**PLANNED UNIT DEVELOPMENT
STAFF REPORT****Date: November 5, 2009****DEVELOPMENT NAME**

The Family Pharmacy of Springhill

LOCATION4401, 4413, 4415, 4417, and 4419 Old Shell Road
(Southeast corner of Old Shell Road and McGregor Avenue)**CITY COUNCIL
DISTRICT**

Planned Unit Development Approval to amend a previously approved Planned Unit Development to allow shared access and parking.

SITE PLAN

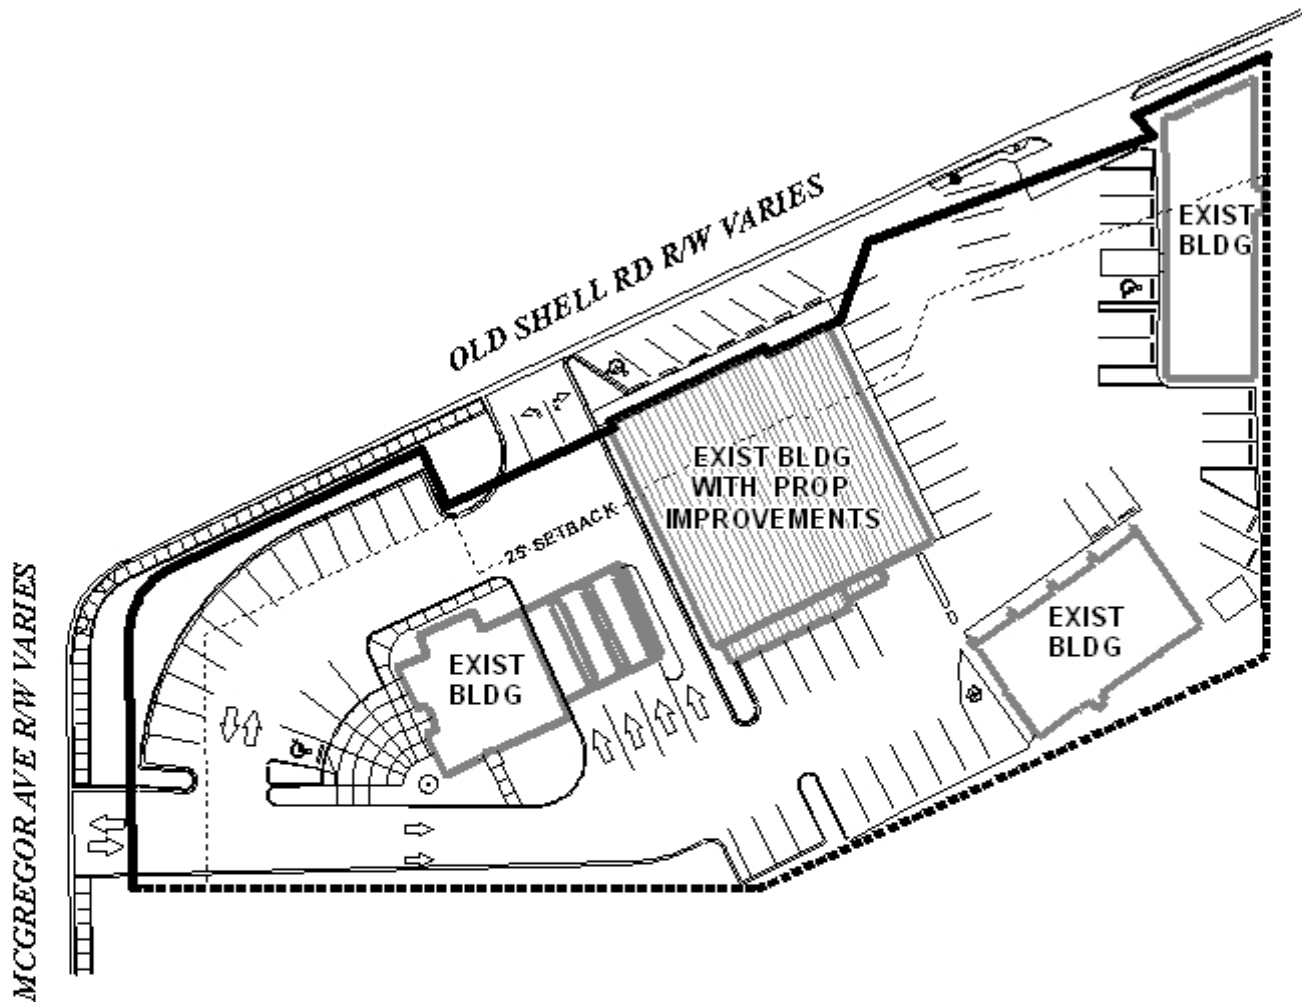
Driveway number, size, location, and design to be approved by Traffic Engineering and conform to AASHTO standards. Eliminate parking spaces that back into the right-of-way of Old Shell Road.

The overall PUD site is developed with four buildings that share access, parking and curb-cuts. Previous PUD staff reports did not address parking on the site, other than to note the existence of seven (7) parking spaces in the right-of-way, which require backing into a travel lane for Old Shell Road: previous reports recommended the removal of these parking spaces as the site is redeveloped (*Traffic Engineering's recommendation with this application includes the removal of the parking spaces which back into Old Shell Road*).

Parking for the overall PUD is a concern. The overall site plan depicts 66 parking spaces, however, 9 of these spaces occur completely or partially within the right-of-way for Old Shell Road. The standard requirements of the Zoning Ordinance state that retail and office uses provide 1 parking space for every 300 square feet of gross building area, while restaurant uses provide 1 parking space for every 100 square feet of gross building area. The Traditional Center

As shown, the site will be a minimum of 10 parking spaces short of the required parking using the standard requirements of the Zoning Ordinance, while the site will have excess parking if the TCDO parking ratio is utilized.

- 6) Compliance with Traffic Engineering comments (*Driveway number, size, location, and design to be approved by Traffic Engineering and conform to AASHTO standards. Eliminate parking spaces that back into the right-of-way of Old Shell Road.*).
